Access Compliance Report

Public Rights-of-Way

(Curb Ramps)

Intersection ID: 50586	Main Street: LONGSTRAW_RD	Cross Street: DOWNY_BIRCH_RD	Location: SE
ADA ID: 6ABD5F61EC05	Ramp Type: Perp	Initial Pass/Fail: Fail	Overall Compliance: No
Severity Score: 33.75			
Codes/Mitigation Info/Possible Solution		Field Measurements/Component Compliance

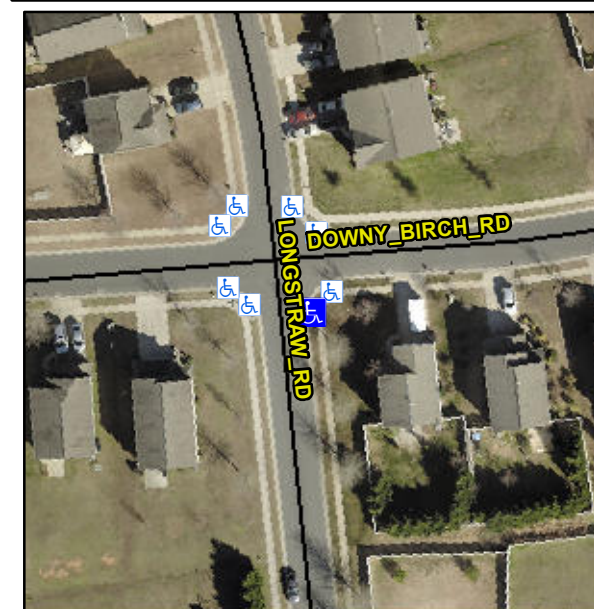
Not Found, R304.5.1, R304.5.3

Compliance	Description	Data	Compliance	Description	Data
N/A	Ramp Length (in)	47.5	Yes	Ramp Slope (%)	5.9
No	Ramp Width (in)	45.5	No	Ramp XSlope (%)	7.3
N/A	Flare Type LT	N/A	N/A	Flare Type RT	N/A
N/A	Flare Slope LT (%)	N/A	N/A	Flare Slope RT (%)	N/A
N/A	Flare Traversable LT?	N/A	N/A	Flare Traversable RT?	N/A
N/A	Landing Length (in)	N/A	N/A	DWS Provided?	N/A
N/A	Landing Width (in)	N/A	N/A	DWS Contrast?	N/A
N/A	Landing Slope (%)	N/A	N/A	DWS Length (in)	N/A
N/A	Landing X Slope (%)	N/A	N/A	DWS Full Width?	N/A
N/A	Landing Curb? (Y/N)	N/A	N/A	DWS Offset (in)	N/A
N/A	Shared Landing?	N/A			
N/A	Gutter Ponding?	N/A	N/A	Gutter Slope (%)	N/A
N/A	Gutter Lip Ht (in)	N/A	N/A	Gutter X Slope (%)	N/A
N/A	Painted X Walk1?	No	N/A	Painted X Walk2?	N/A
	X Walk 1 Direction	To W		X Walk 2 Direction	N/A
N/A	X Walk 1 Width (in)	N/A	N/A	X Walk 2 Width (in)	N/A
	X Walk 1 Slope (%)	0.5		X Walk 2 Slope (%)	N/A
	X Walk 1 X Slope (%)	2.6		X Walk 2 X Slope (%)	N/A

Remove & Replace Entire Ramp.
